IN THE DRAWINGS

Please amend the drawings as follows:

FIG. 2

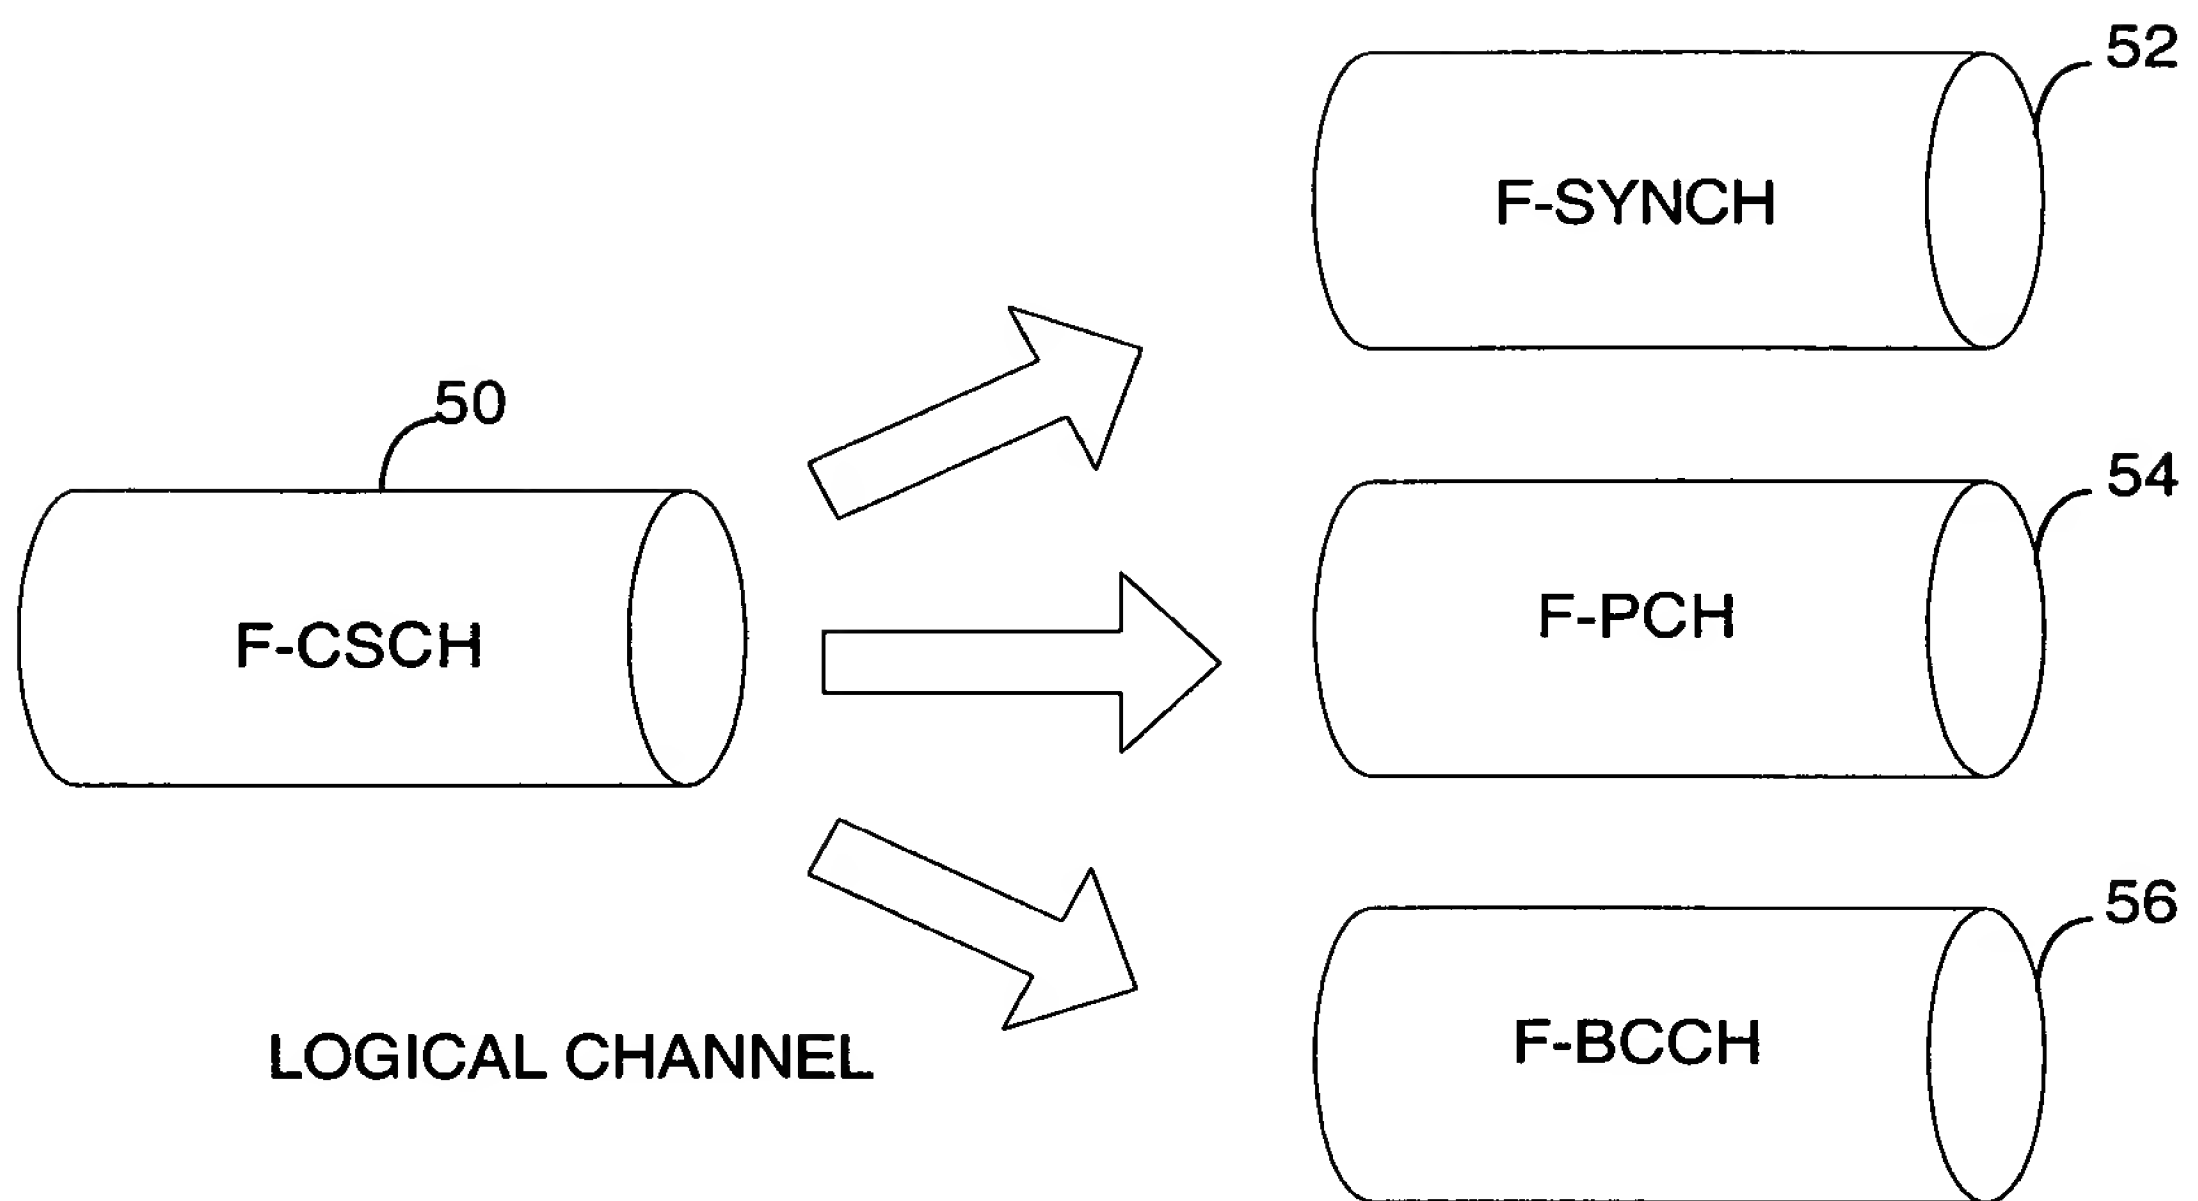
- FIG. 2 Amend “f-sch” in element “50” to read “F-CSCH.” Applicant refers to page 6 line 27.
- FIG. 4 Amend the interval from time t3 to t6 and the interval from time t6 to t9 to each be labeled “FRAME,” as shown in the attached amended drawing. Applicant refers to page 8, line 10 of Applicant’s specification.
- FIG. 8 Amend “TRANSMIT CIRCUITRY 216” as shown as in the attached amended drawing. Applicant refers to page 14, line 7 of Applicant’s specification.
